**STATE OF DELAWARE
EXECUTIVE DEPARTMENT
OFFICE OF STATE PLANNING COORDINATION**

RE: PLUS review 2014-06-01, Reserves at Nassau, Phase 2

Thank you for meeting with State agency planners on June 25, 2014 to discuss the proposed plans for the Reserves at Nassau, Phase 2. According to the information received, you are seeking site plan review for the development of 147 residential units on 36.98 acres located in Sussex County.

Water Resource Protection Areas

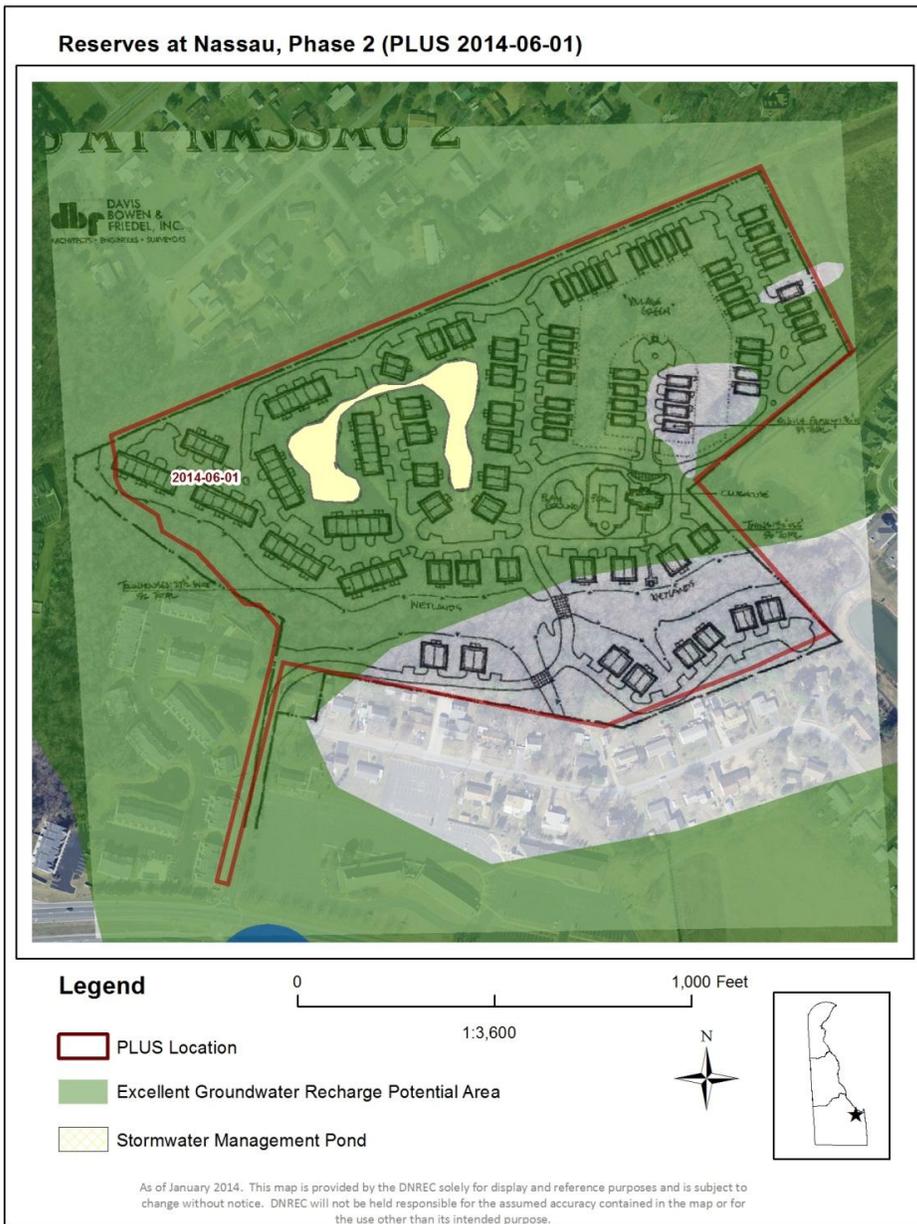
- The DNREC Water Supply Section, Groundwater Protection Branch (GPB) has determined that a portion of the project site falls within an excellent ground-water recharge potential area for Sussex County (see attached map).

The site plan shows wet ponds for the management of stormwater (see map below). Wet ponds intersect the water table and have the potential to affect the water quality of the aquifer. Some research suggests that pollutant removal is reduced when ground water contributes substantially to the pool volume (Schueler, 1997). Wet ponds as a Better Management Practice (BMP) utilize a settling pond to remove particulates. This type of BMP reduces nutrients by the biological activity of alga. While these systems address the particulate and nutrient components of stormwater runoff, they do not address pathogens, petroleum hydrocarbons, pesticides, other organic compounds, and other inorganic compounds associated with residential land use (DNREC, 1999). Because this is an area of excellent recharge potential, there exists the potential for these constituents to enter the aquifer and compromise water quality.

DNREC recommends that wet ponds should be located outside the excellent ground water recharge potential area. In addition, because the excellent ground water recharge area can readily affect the underlying aquifer if contaminants are spilled or discharged across the area, the storage of hazardous substances or wastes should not be allowed within the area unless specific approval is obtained from the relevant state, federal, or local program.

Reserves at Nassau Phase 2 with Effective Sussex Co. FIRM

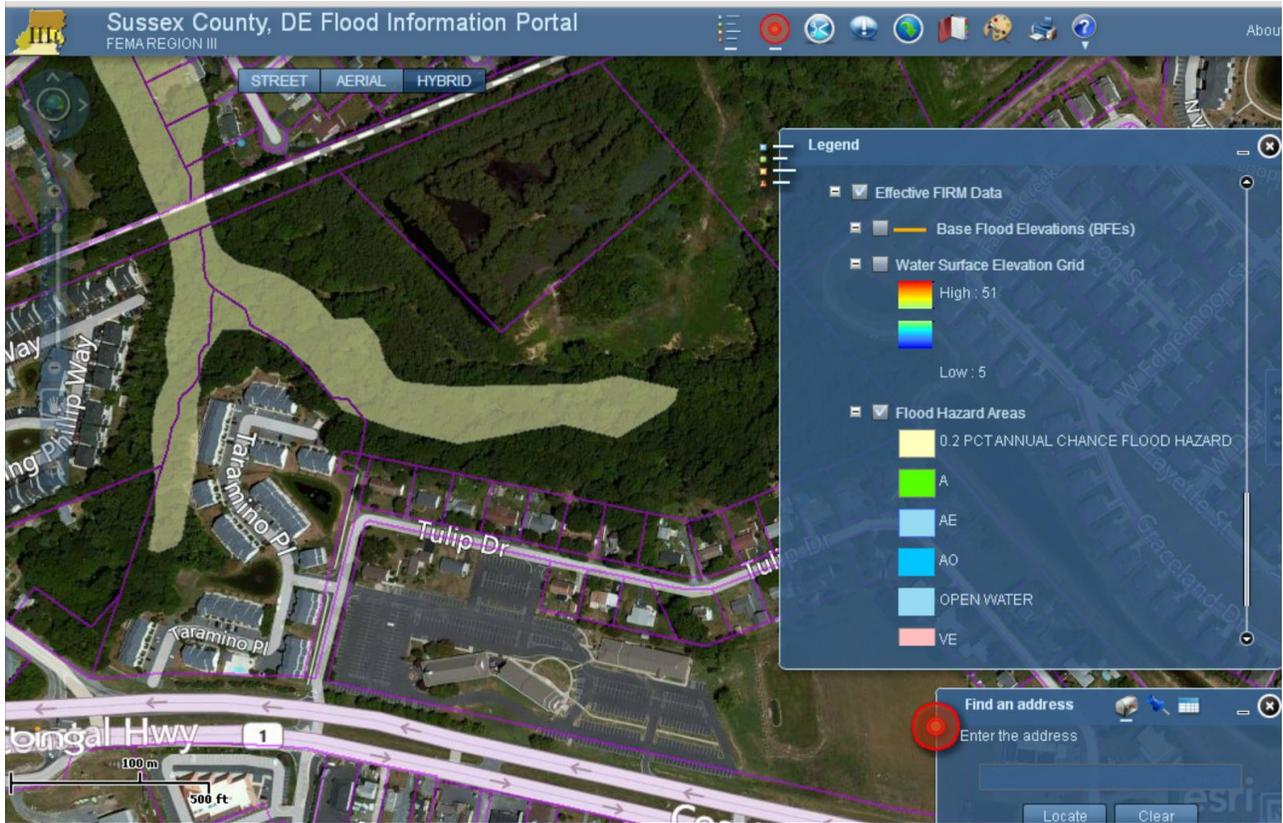
- The project parcel currently contains a moderate risk, 0.2% annual chance special flood hazard area, as shown on the current effective Flood Insurance Rate Map (FIRM).

- Recommendations:
 - Lots within flood prone areas should be eliminated.
 - Any structure built within a mapped floodplain should be constructed with 18” of freeboard. Any structures that are built within an area mapped as both floodplain and sea level rise zone should be constructed with 18” of freeboard plus additional freeboard to accommodate future sea levels.

- Filling lots to elevate them to above base flood elevation is discouraged.
 - Access roads should be designed to be flood resilient for the entirety of its design life span. This includes ensuring that the roadway functions for the 1% chance flood plus anticipated future sea level rise.

Reserves at Nassau Phase 2 with Preliminary Sussex Co. FIRM

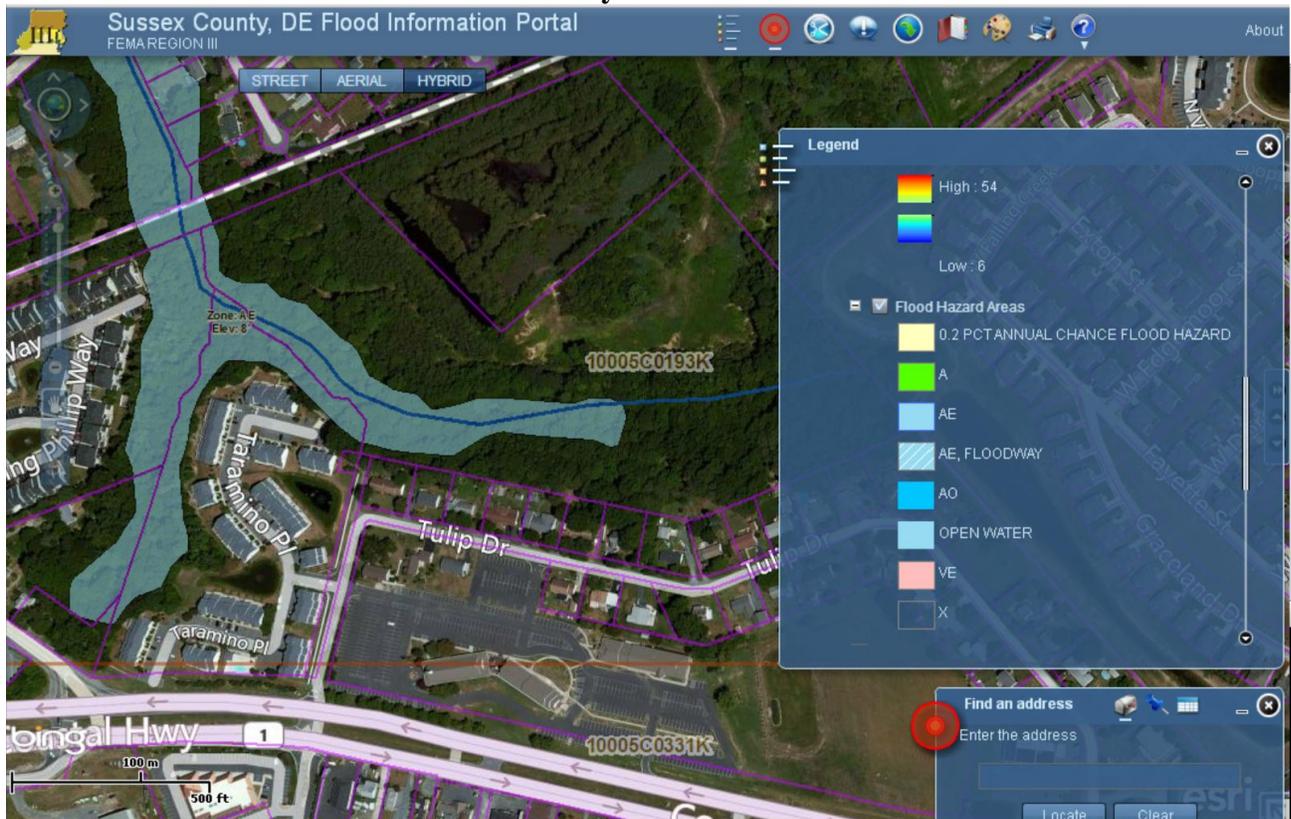
These FIRMs have been recently updated by FEMA. In new FIRM, a portion of the parcel will be located in a high risk, 1% annual chance special flood hazard area (Zone AE with a base flood elevation), as shown on the preliminary Flood Insurance Rate Map. (<http://maps.riskmap3.com/DE/sussex/>).

- These preliminary maps are scheduled to become effective in March 2015. Any construction on the parcel will have to comply with the Sussex County floodplain regulations and the map in effect at the time the permit is issued. DNREC encourages the developer to take into account complying with floodplain building standards if lots are to be placed in the preliminary floodplain. How the structures are built will have an impact on the cost of the future owners flood insurance rates.

Figure 1: NRCS soil mapping update in the immediate vicinity of the proposed project

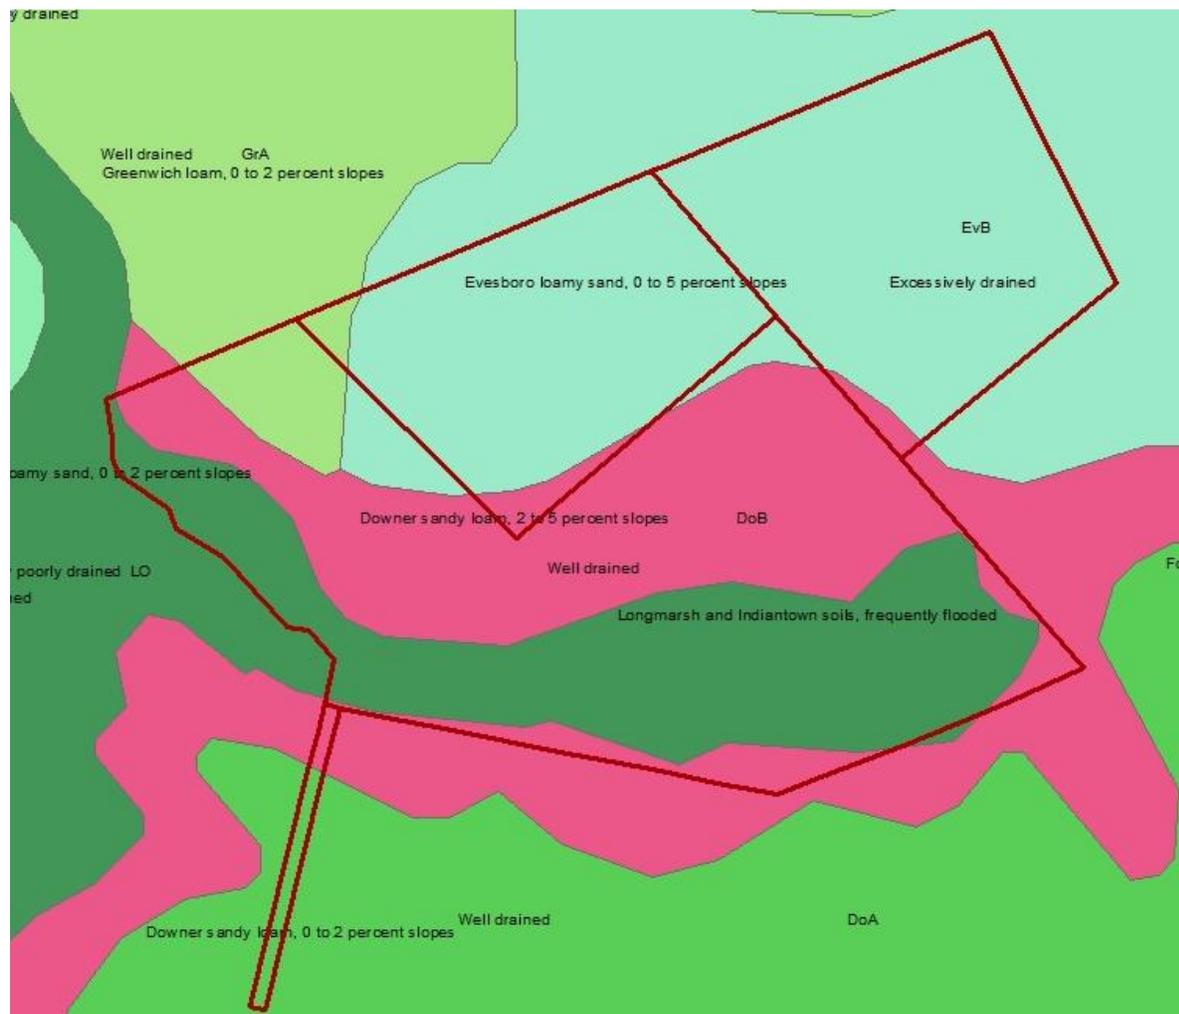
- **Soils assessment**Based on soils survey mapping update, the Longmarsh and Indiantown (LO) soil mapping unit is the main soil mapping unit in the immediate vicinity of the proposed project; we strongly recommend the applicant avoid this mapping unit. LO is a very poorly-drained wetland associated (hydric) soil mapping unit that is considered to have severe limitations for development (i.e., considered unsuitable). Potential unmapped hydric soils may also be present in this parcel.

- Avoid all hydric soil mapping units. Building on such soils is likely to contribute to an increased probability of future onsite and offsite flooding problems. An evaluation of this parcel by a licensed (Class D) certified (ARCPACs) soil scientist, is strongly recommended.
